CHANGE ORDER NUMBER: 1

Project: 1809-261

Roadway: CR 110 Middle

Change Order No. 1

MA-C (ILSN) - 12

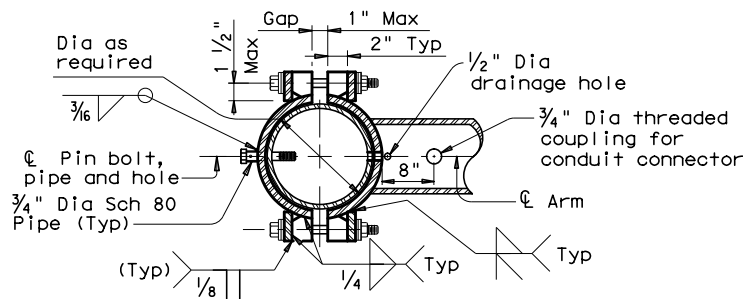
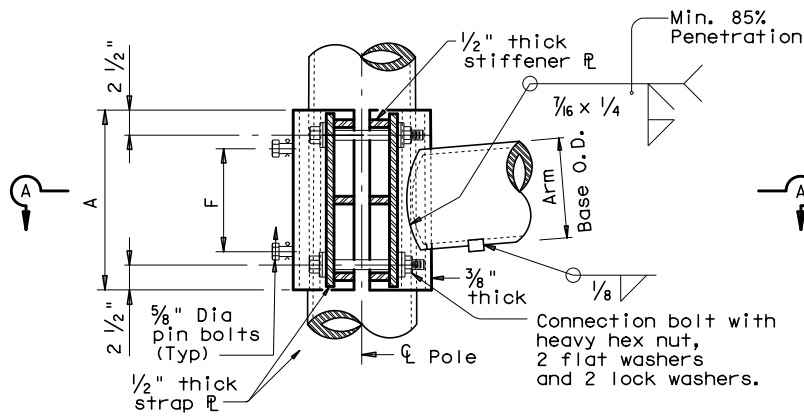
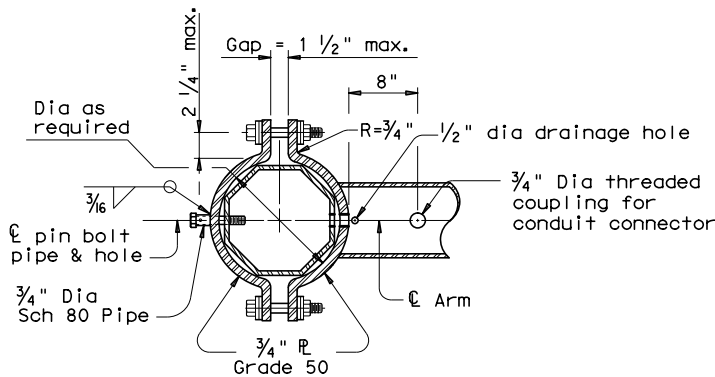
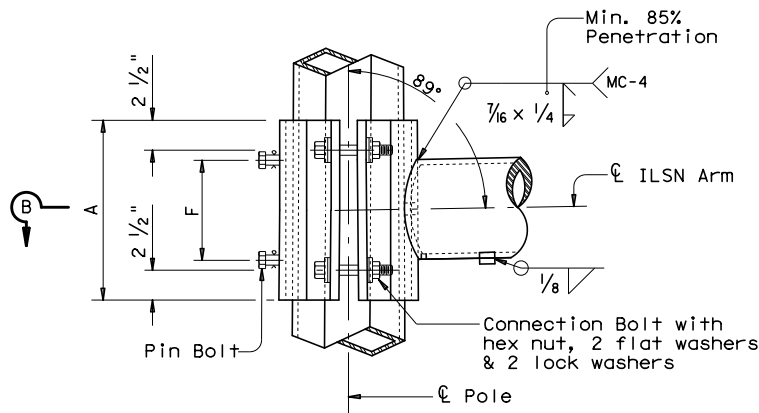
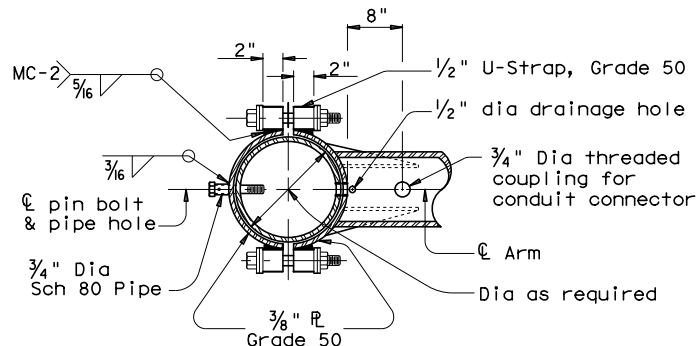
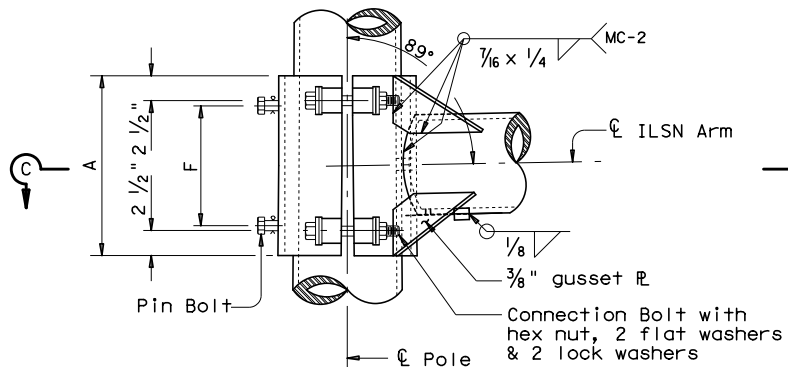
Please also let this change order acknowledge added Sheet 148A and revised Sheets 5, 132 (previously only redlined), 137, (previously only redlined), 137B, 137C, 137E, 137G and 145.
